UNITED STATES PATENT AND TRADEMARK OFFICE

APPLICATION NO.	FILING DATE	FIRST NAMED INVENTOR	ATTORNEY DOCKET NO.	CONFIRMATION NO.
10/694,253	10/27/2003	Tim Roland	4041A-000010	2690

Office Action Summary

DETAILED ACTION

FIG - 1

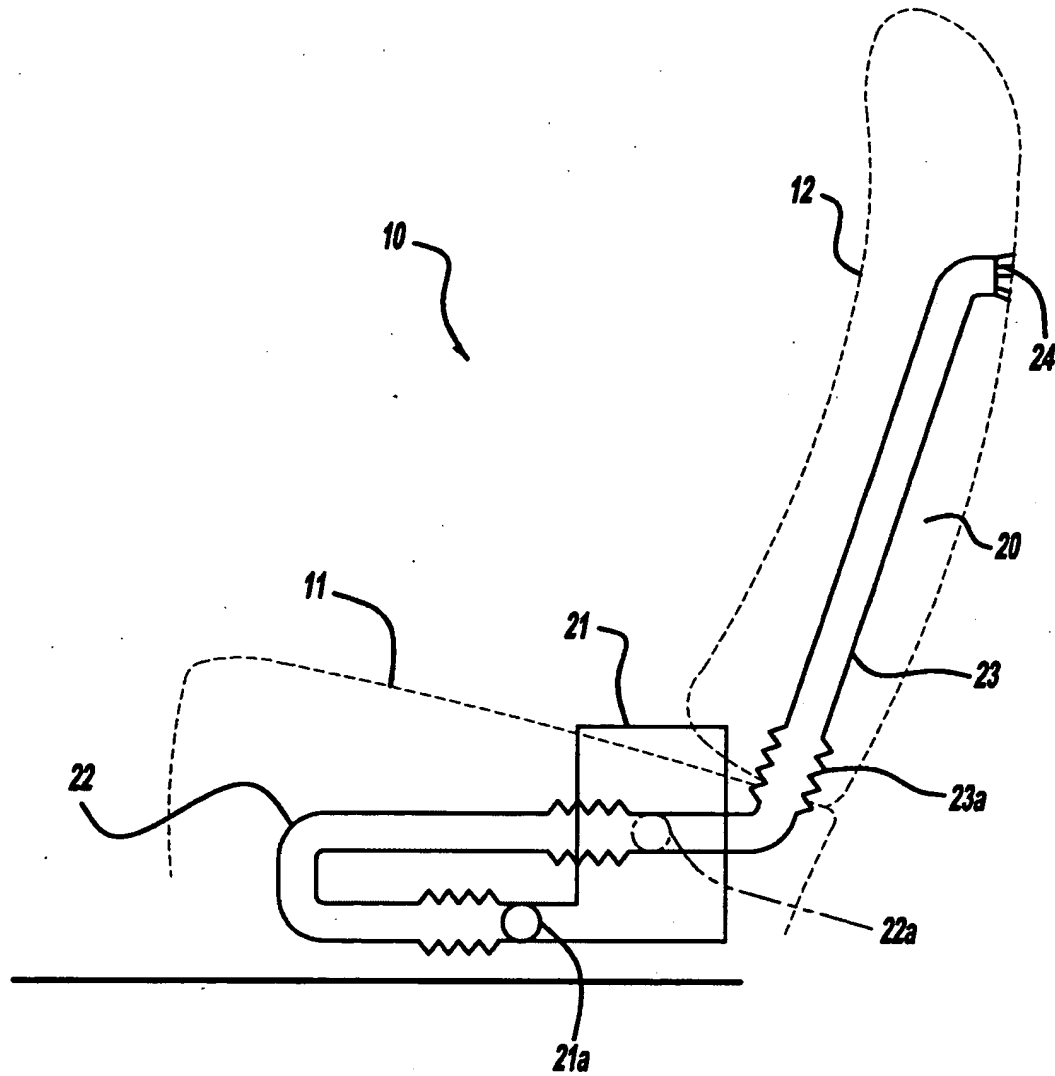
5. The drawings were received on May 9, 2006. These drawings are disapproved.
6. The originally filed drawings and the drawings filed on May 9, 2006 are objected to under 37 CFR 1.83(a). The drawings must show every feature of the invention specified in the claims. Therefore, the center duct located *in a center console of the vehicle* as recited in claim 1 and the center connection duct located next to the seat bottom portion *between vehicle seats* as recited in claim 17 must be shown or the feature(s) canceled from the claim(s). Note that even paragraph [0022] of the specification states that the center console of the vehicle is NOT shown in the drawings. No new matter should be entered.

not
approved.
A/C
10-07-06

FIG - 2

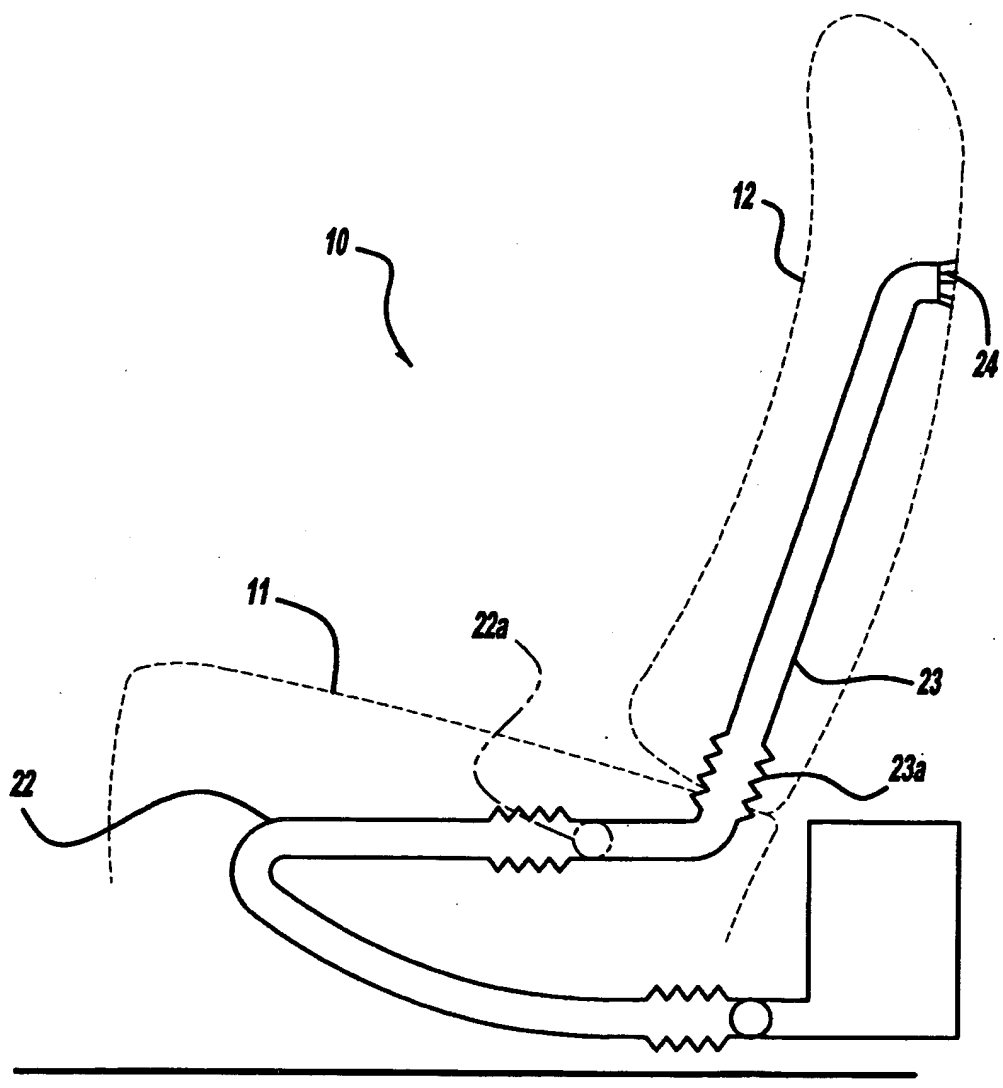
not
approved.
LRC
10-07-06

FIG - 3

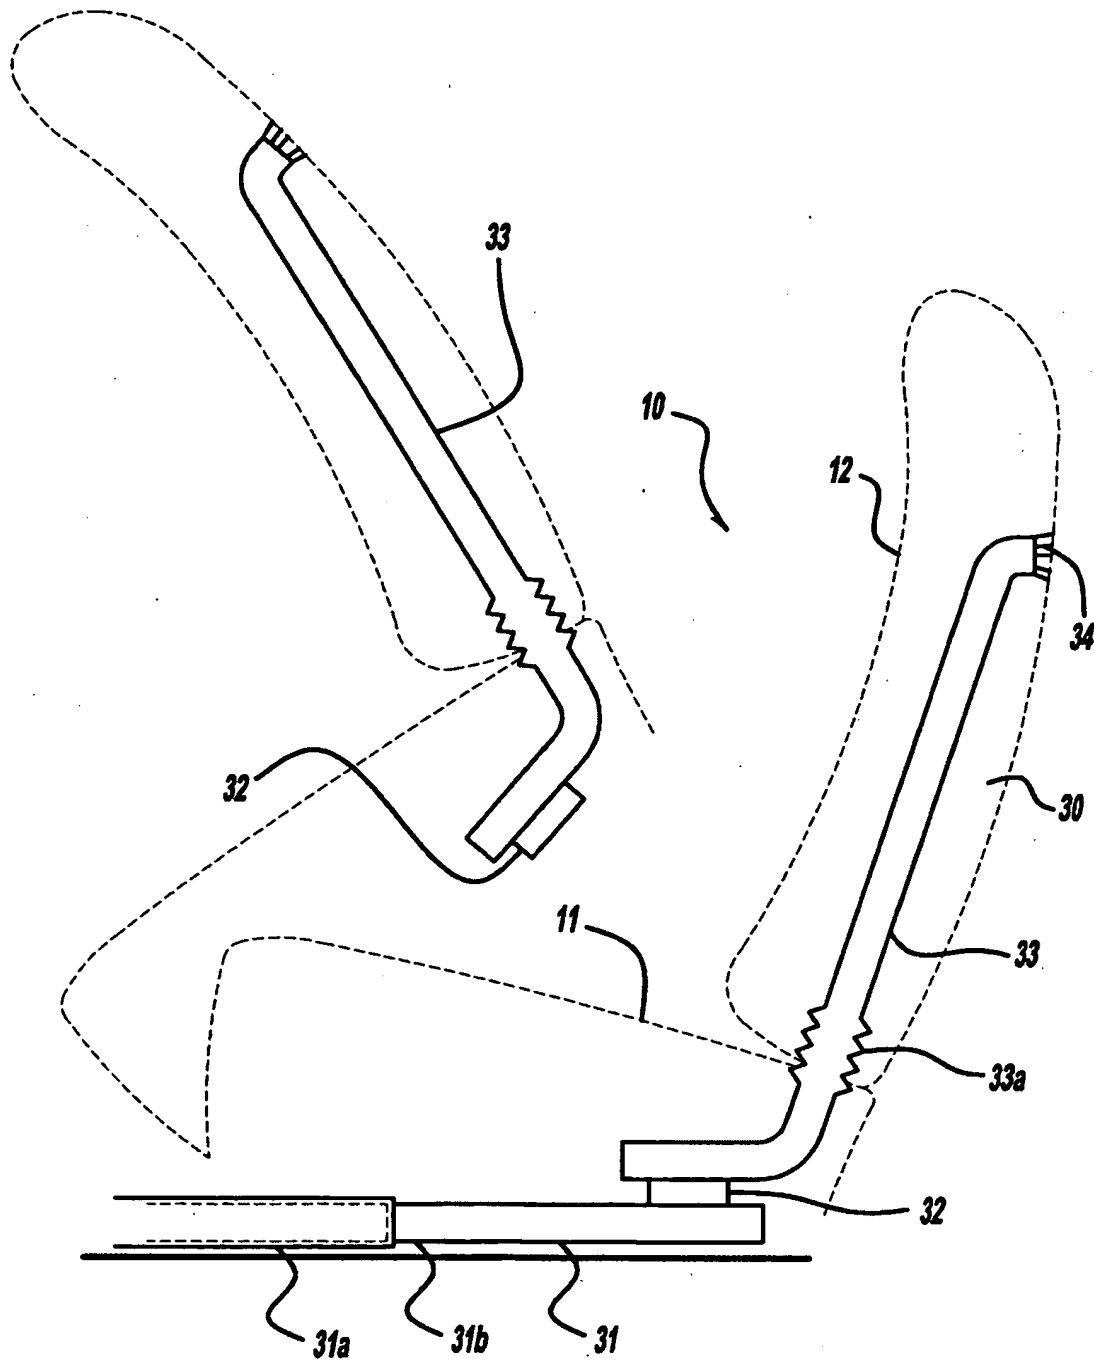
Not
approved
of VC
10-07-06

FIG - 4

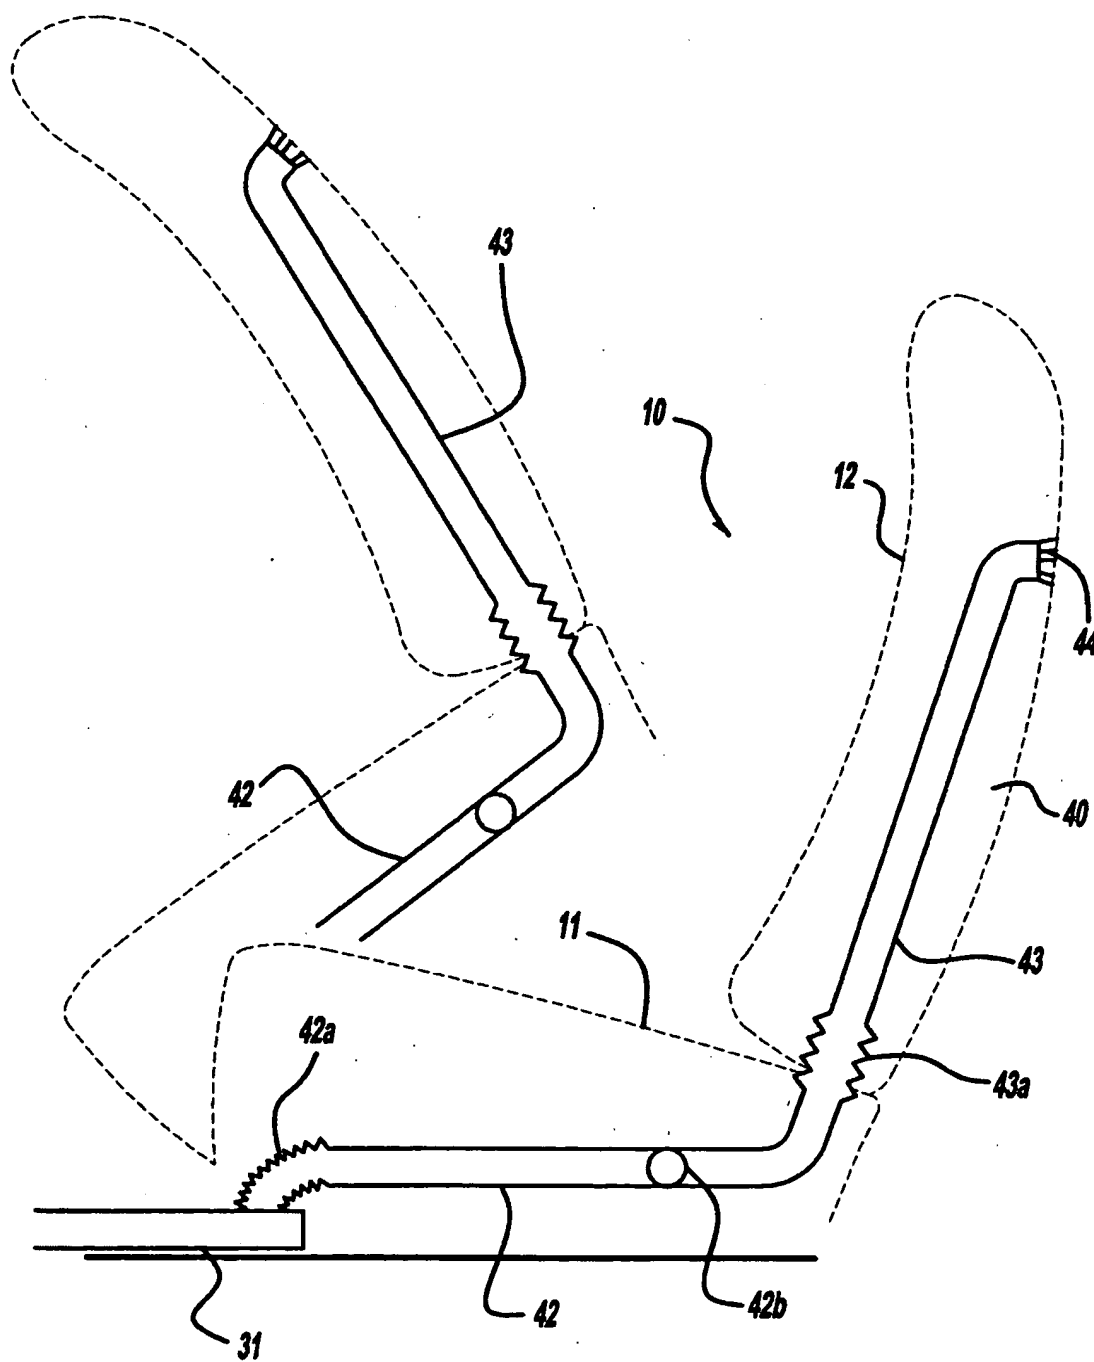
Not
approved.
ARC
10-07-06

FIG - 5

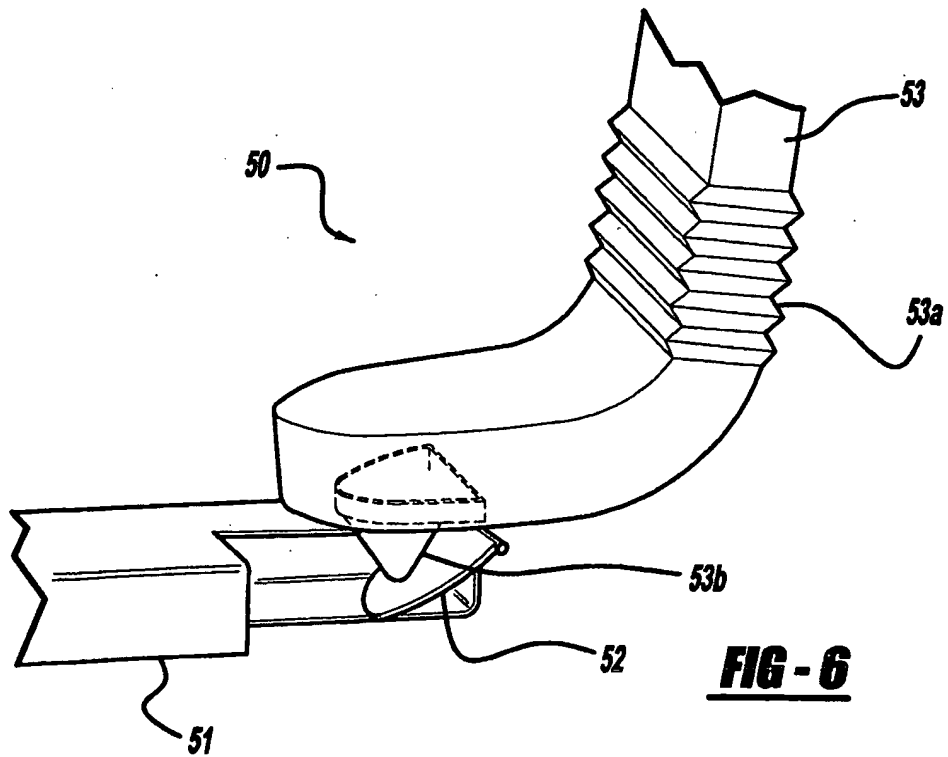
Not
approved.
DVC
10-07-06

FIG - 6

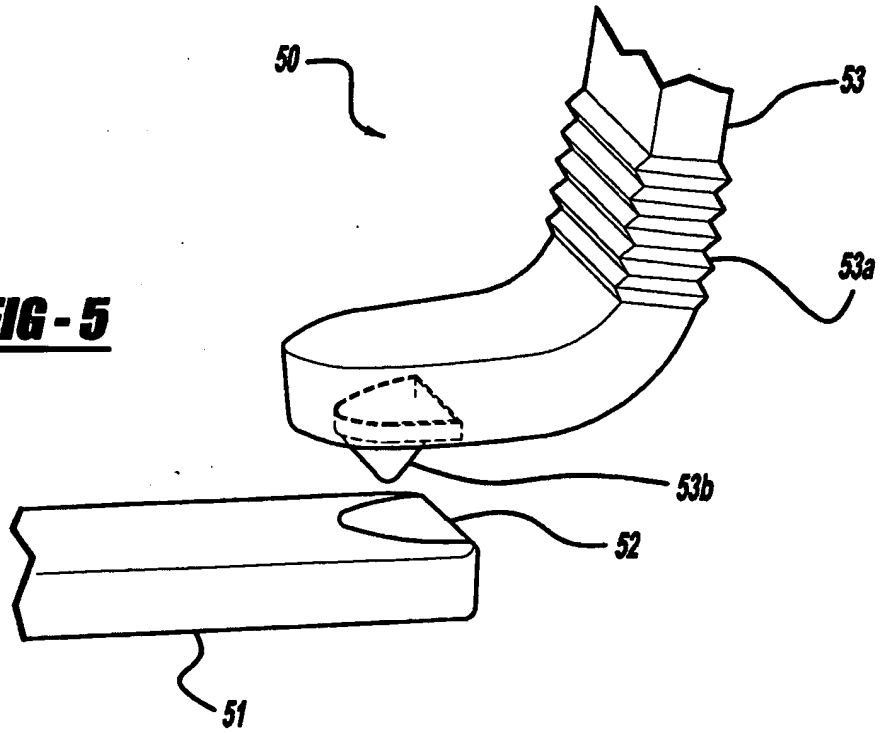
not approved.
CNC
10-07-06
